**Addendum for Request for Proposal**

**Linkhorne Elementary Courtyard Redesign Project**

**14-904**

Date: 05/01/2014  
From: Lisa Moss, Buyer VCA  
RE: Addendum No. 1

Courtyard

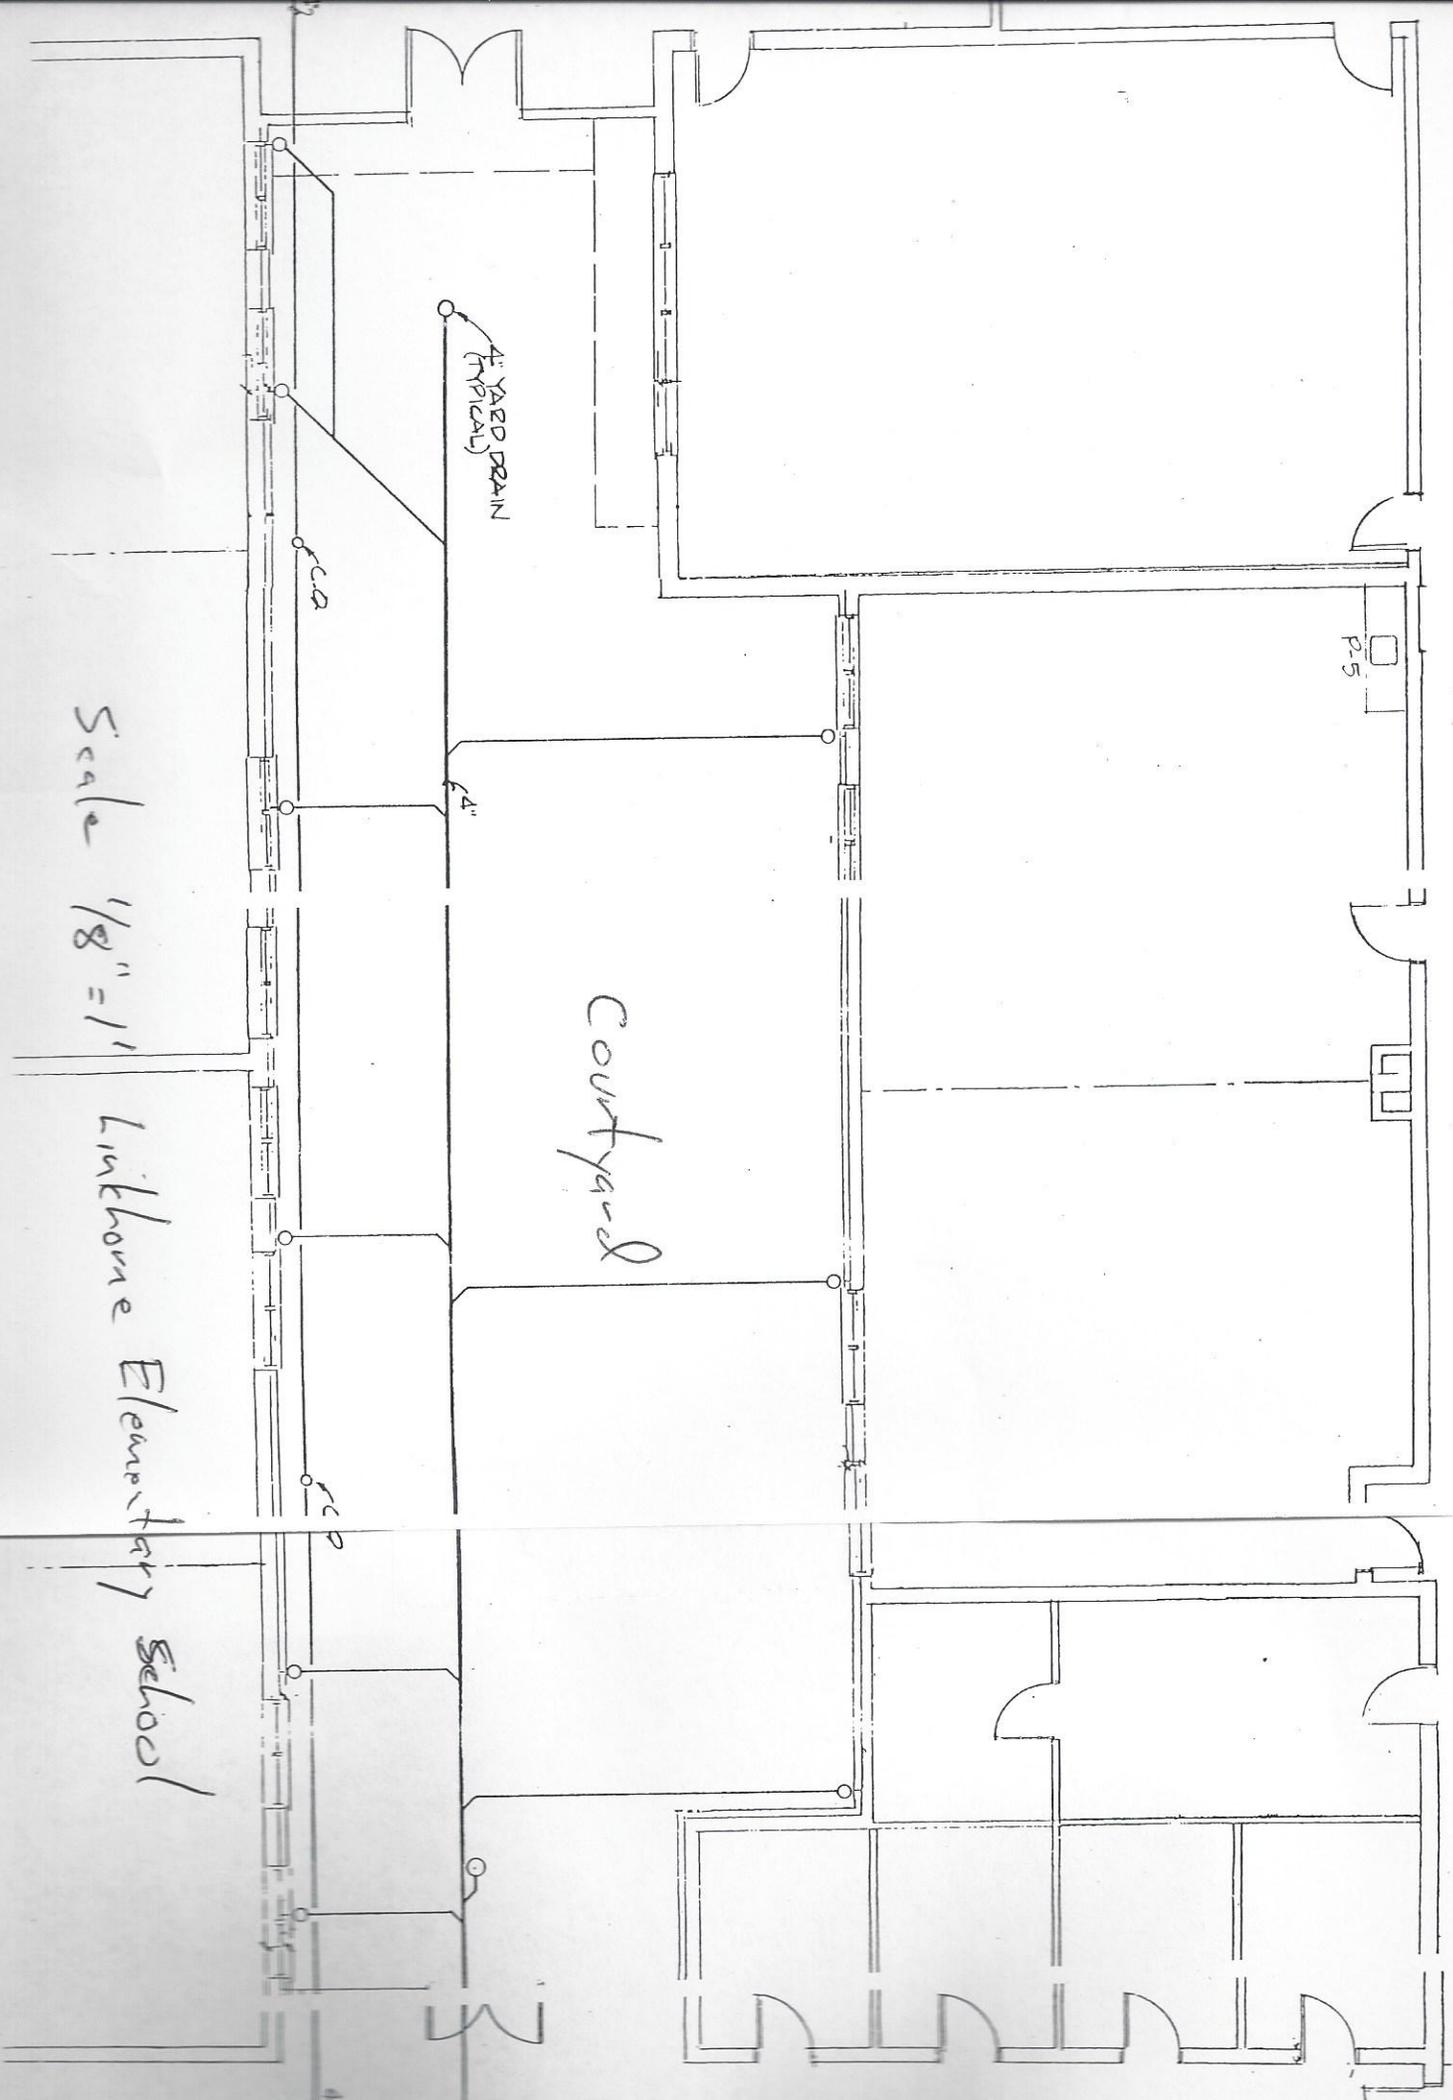
6. Can you please provide information on the drains in this courtyard and if there are any current drainage issues?

7. Is there a survey of this area available? Looking for downspout exit points and if they tie into any drains.

**There are no current drainage issues that we are aware of. Attached below is a copy of the drain in the courtyard.**

**There are nine downspouts and two yard drop inlets that connect to a common collector that runs longitudinally through the courtyard. In addition there is a sanitary sewer line located along the north wall of the courtyard. These lines are shown on the drawing. \* Drawing attached below\***
